HVOLT Inc.

US Department Of Energy
Distribution Transformers 2019STD0018@ee.doe.gov
Federal eRuling Portal

Subject: NOPR EERE-2019-BT-STD-0018

Figure 3 shows chart 14 from the 2023 EIA recently released forecast

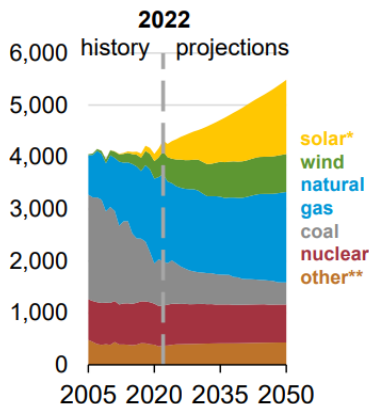
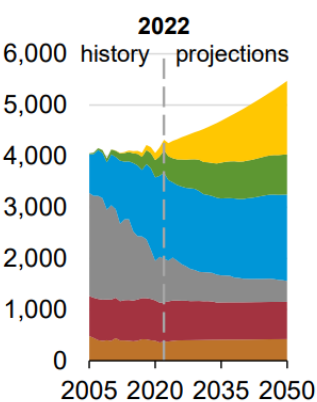
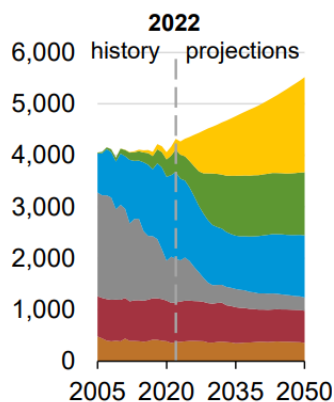
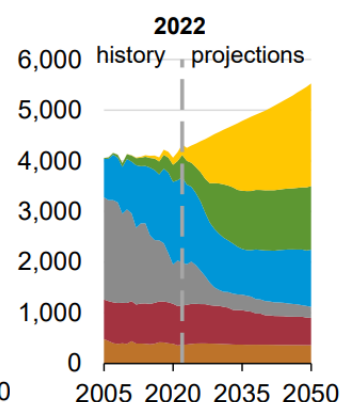
The EIA's 2023 forecast, just published this month, is always very conservative but has now upped the growth of electrical energy to 0.9%/yr. from <0.5%/yr., or about twice as much as the 2022 forecast. This now amounts to a 35% increase from 2022 through 2050. Recognizing the actual 3.3% growth from 2021-2022, it is likely that the future growth will be much more rapid and quickly drives home the importance of low transformer load loss over core loss reductions. Chart 14 from the DOE's EIA 2023 forecast shows their new projections graphically. This new report, with twice as much growth over the year earlier report, is a significant factor that should cause the DOE to reassess its report.

1. Devoid of consideration for large loading increases that are starting to show up as in figures 2 and 3 of this report.
2. Capricious in the product types that will be asked for reductions in losses per figure 1.

Figure 4 shows a 1500 kVA design comparison between GOES in yellow and Amorphous in black that meet the DOE 2016 efficiencies.

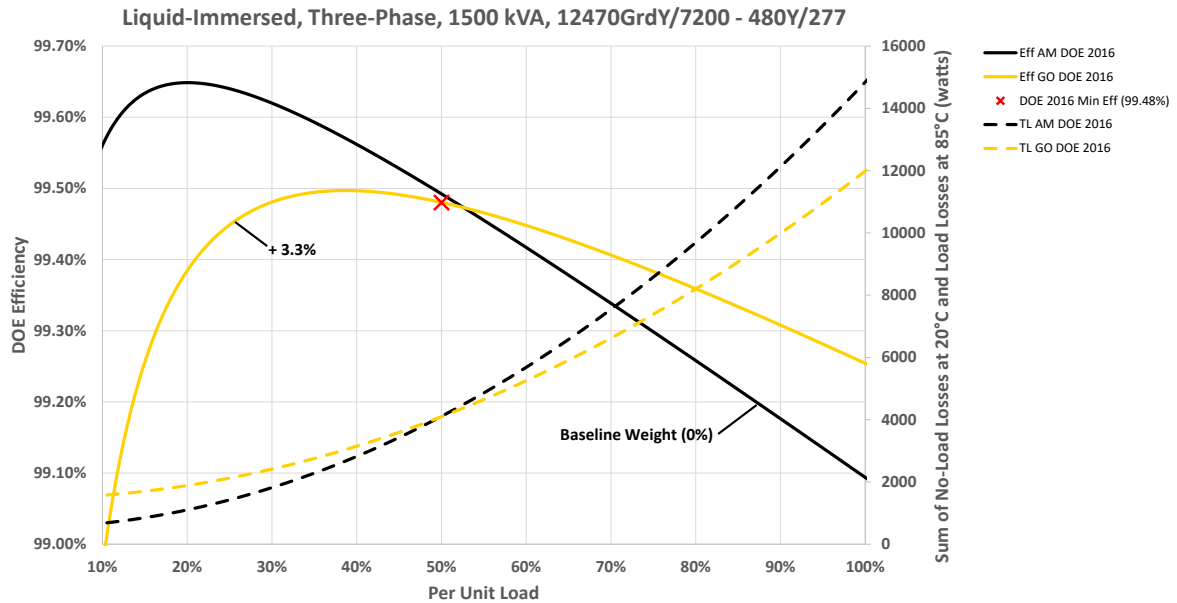
1. With large increases in load growth over the forecast, it does not seem to be appropriate or wise to concentrate on Amorphous Cores, which claim to have peak efficiency at 20% load. If we look at only the 2016 plots above of % efficiency versus % load, it is clear that amorphous cores indeed hit peak efficiency at 20% load. Interestingly, transformers with amorphous cores are not as efficient at greater than 50% load as GOES transformers. In fact at 100% load, amorphous core transformers have 50% higher total loss than GOES. With loading increasing so fast, I recommend that the DOE reconsider the amorphous direction, and not implement any standards that exclude GOES.

Figure 5.6.7 Engineering Analysis Results, RU7, 2021

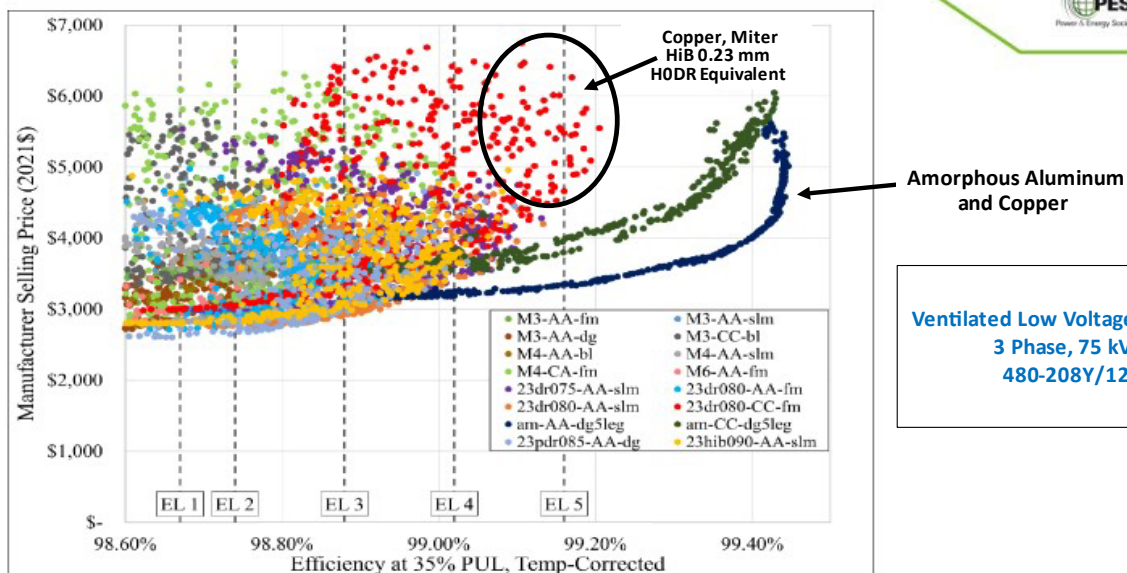
1. Cleveland Cliffs is currently the only domestic manufacturer of GOES core materials. By the DOE's admission, implementation of the NOPR will mean that GOES materials will not be able to compete with Amorphous cores and will largely be driven out of business. This chart shows well for LV Dry transformers, the core materials that have produced designs as a function of Energy Standard Level. Since LV Dry transformers are proposed in the NOPR to move to TSL 5, the only core materials that can comply use amorphous cores:

3-Phase LV Dry losses proposed to drop by 40%

Figure 5 shows the DOE scatter plot of usable core materials versus efficiency levels.
